## **Planning Commission Staff Report**

**Subject:**                   **Issues Report**

**Petition:**                P.Z. 02-2008 Stallone Pointe (Conway Pointe, L.L.C.)

Re: Stallone Pointe (Conway Pointe, L.L.C.)  
15446 Conway Road  
Chesterfield P.Z. 02-2008  
CEDC Project 0332.10

## PRELIMINARY DEVELOPMENT PLAN

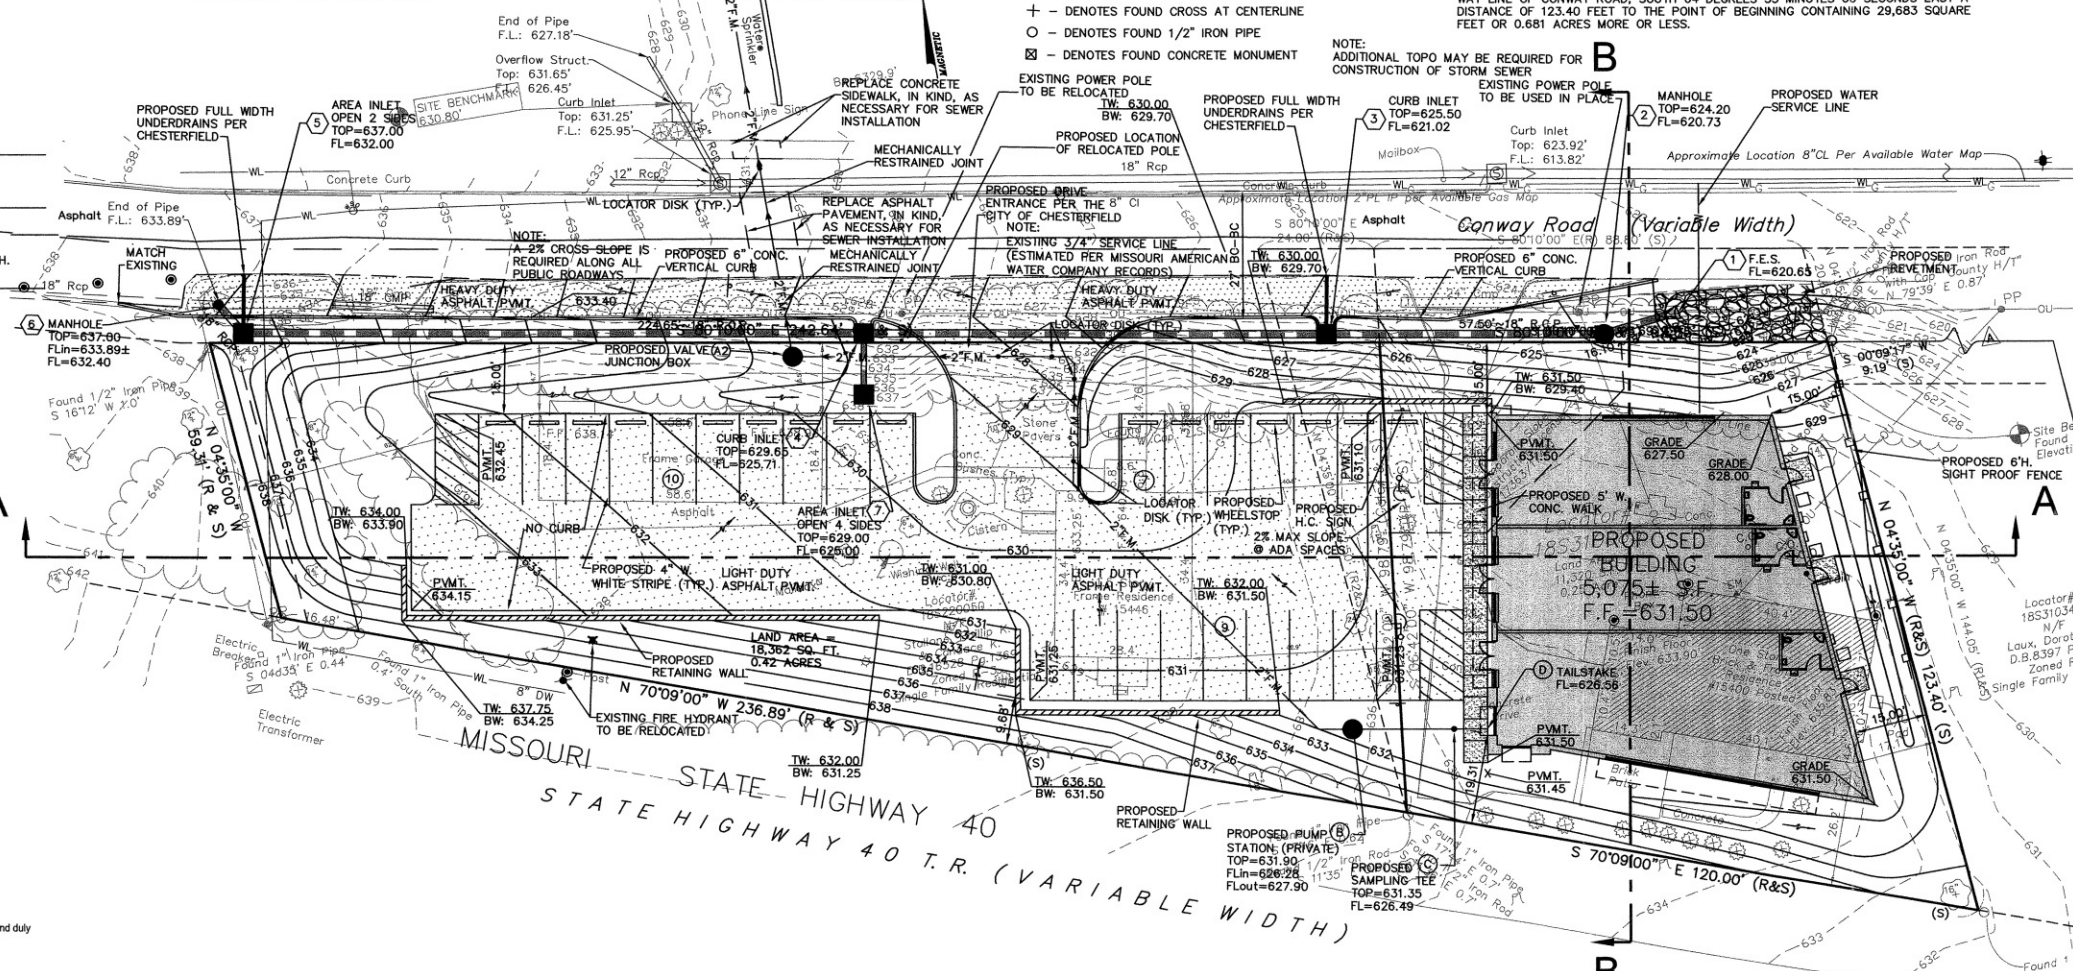
1. The applicant did not clarify the market use.
2. The applicant did not provide a list of potential effects that this development may have on the adjacent residential property to the east. The response provided was that the adjacent property was classified as Urban Core by the Comprehensive Plan and that it will at some point be developed as such.
3. The site as designed does not meet all requirements of the City of Chesterfield Tree Manual. Staff is currently reviewing two (2) variance requests by the applicant.
  - a) The City of Chesterfield Tree Manual, Ord. 2367, requires that a thirty (30) foot buffer be provided along proposed non-residential zoning districts that abut residential zoning districts. The applicant is requesting

a variance from this standard to provide for a six (6) foot high sight proof fence to mitigate this issue. The Department of Planning & Public Works is currently reviewing this request.

- b) The City of Chesterfield Tree Manual, Ord. 2367, requires that a thirty (30) foot buffer be provided along major arterials. The applicant is requesting a variance from this standard and proposes a minimum eighteen (18) foot buffer along the southern side of the property nearest to the proposed structure and a minimum four (4) foot buffer along the southern side of the property nearest to the parking area. The Department of Planning & Public Works is currently reviewing this request.

4. Ordinance 1747, requires that a thirty-five (35) foot setback exist where a "PC" Planned Commercial District with a Retail Use abuts an "R3" Residence District (10,000 Square Feet). The applicant is proposing a fifteen (15) foot setback due to the Comprehensive Plan Land Use Designation for the adjacent property. Both properties are designated Urban Core; as such the land uses commonly associated with this designation are office and commercial. If both properties were zoned accordingly, per Ordinance 1747, no minimum setback would be required.

4. *Ensure that the required thirty (30) feet of landscaped buffer is provided along both the east side of the property, adjacent to the residential zoning district, and the south side of the property, fronting US Highway 40/61, per Chesterfield Tree Manual, Ordinance 2367, section XIII B.1.*

5. *Ensure that the required setback from the adjacent "R-3" Residential Zoning District of thirty-five (35) feet is met along the eastern property line, per Chesterfield Ordinance 1747 section 1(2)(e).*

**Response:** We are requesting the East and South set-backs be amended as shown on the plan, to allow this project to be viable due the properties narrowness. The property to the east is listed as "Urban Core" on the comprehensive plan, which would require less than the 30 feet set-back. The frontage of US Highway 40/61 has approximately 30 feet of green space from the south property line to the northern west bound lane. A reduction as shown on the plan seems appropriate, while maintaining significant open space

**Response:** We are requesting the East and South set-backs be amended as shown on the plan, to allow this project to be viable due the properties narrowness. The property to the east is listed as "Urban Core" on the comprehensive plan, which would require less than the 30 feet set-back.
